UNITED STATES
DEPARTMENT OF THE INTERIOR
BUREAU OF LAND MANAGEMENT

FORM APPROVED
OMB NO. 1004-0135
Expires: July 31, 2010**SUNDRY NOTICES AND REPORTS ON WELLS**
Do not use this form for proposals to drill or to re-enter an abandoned well. Use form 3160-3 (APD) for such proposals.

Cimarex Energy Co. respectfully requests approval to change the casing design, cement design and BOP requirements as follows:

Cimarex Energy Co.
 Triste Draw 30 Federal #3H
 30025-41176

Exhibit E-1 -- 2000# BOP
Triste Draw 30 Federal 3H
Cimarex Energy Co.
30-23S-33E
SHL 330 FSL & 1980 FEL
BHL 330 FNL & 1980 FEL
Lea County, NM

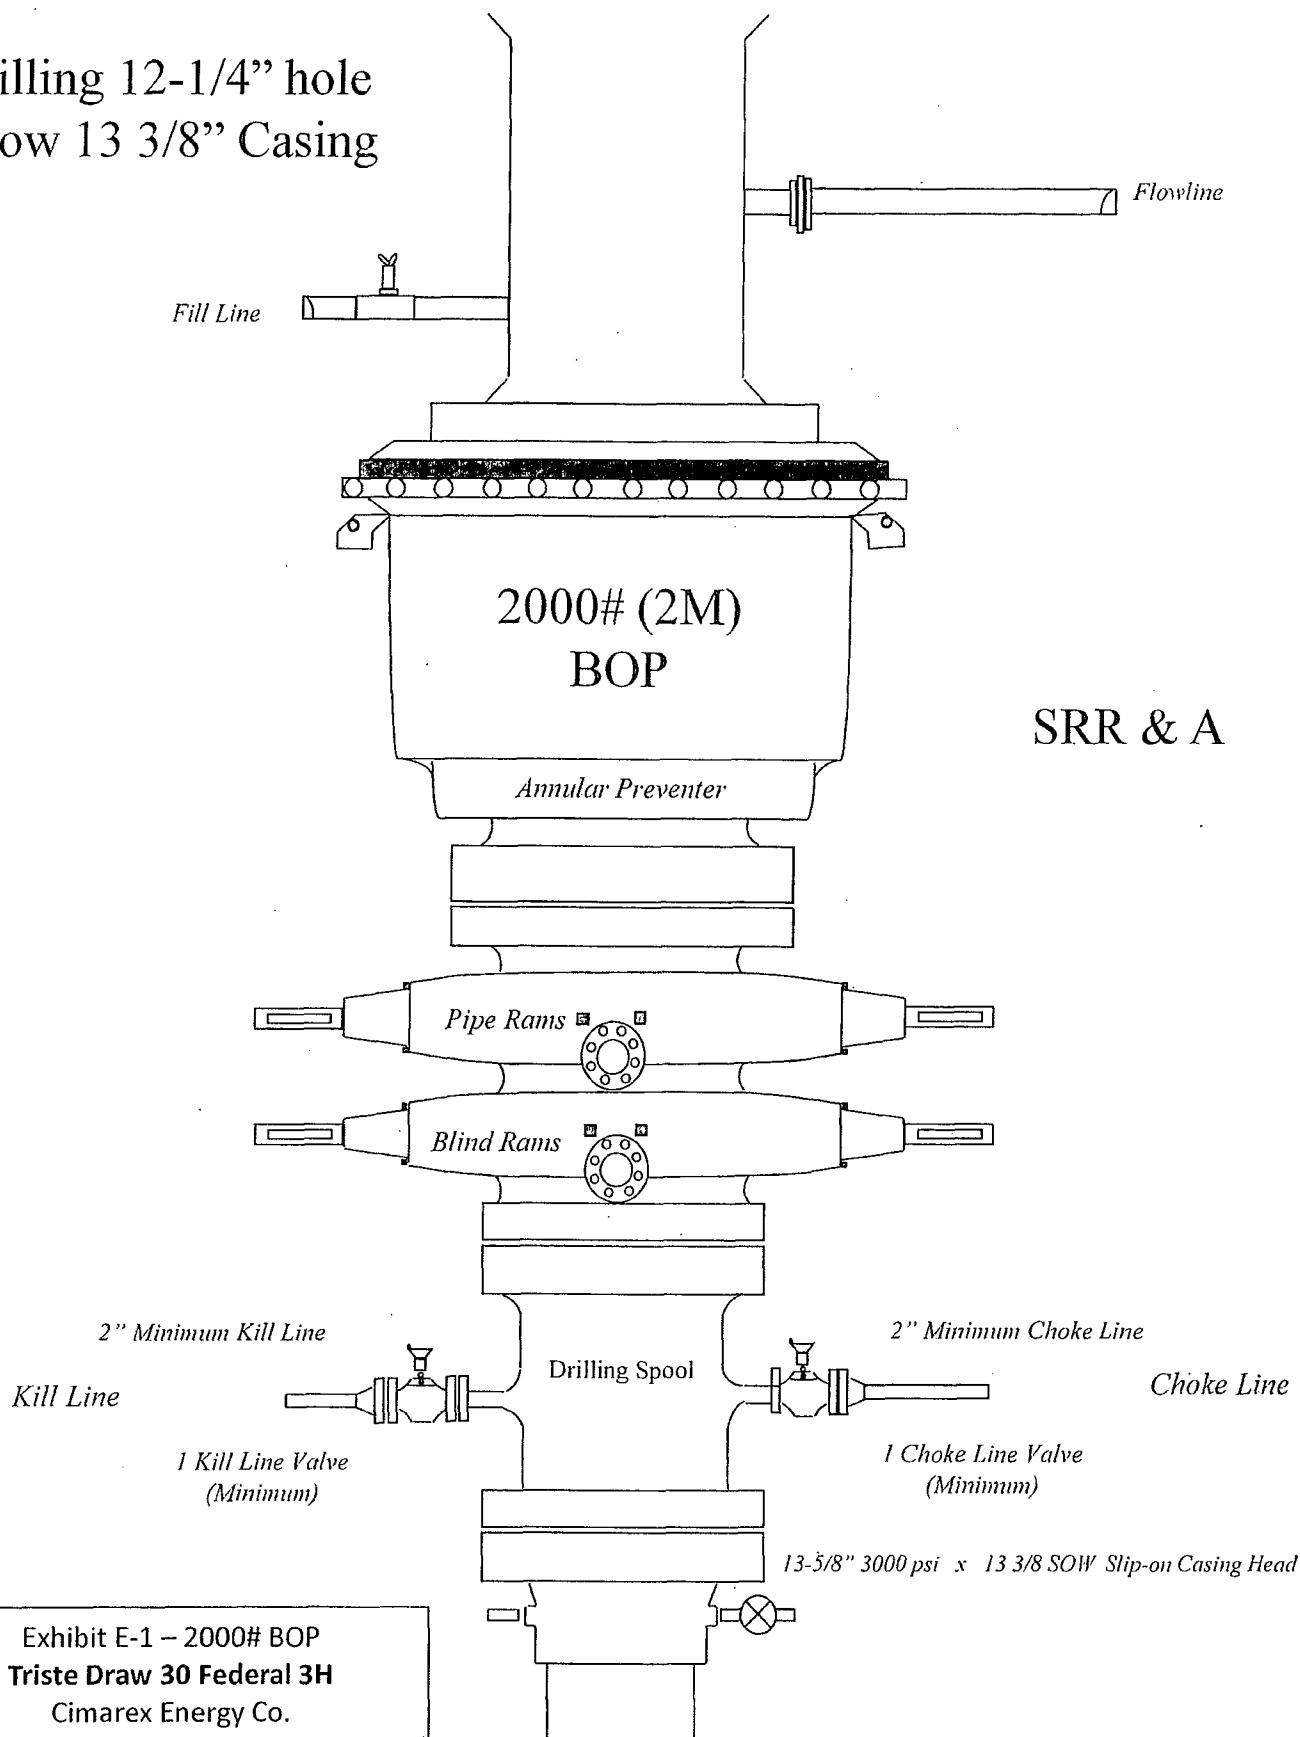
~~A variance is requested for the use of a diverter on the surface casing. See attached for schematic.~~

Proposed: 2M system below surface and 3M system below intermediate. BOP schematic attached.
Pressure Control Equipment data sheet attached.

Approved: 3M system below surface and 5M system below intermediate.
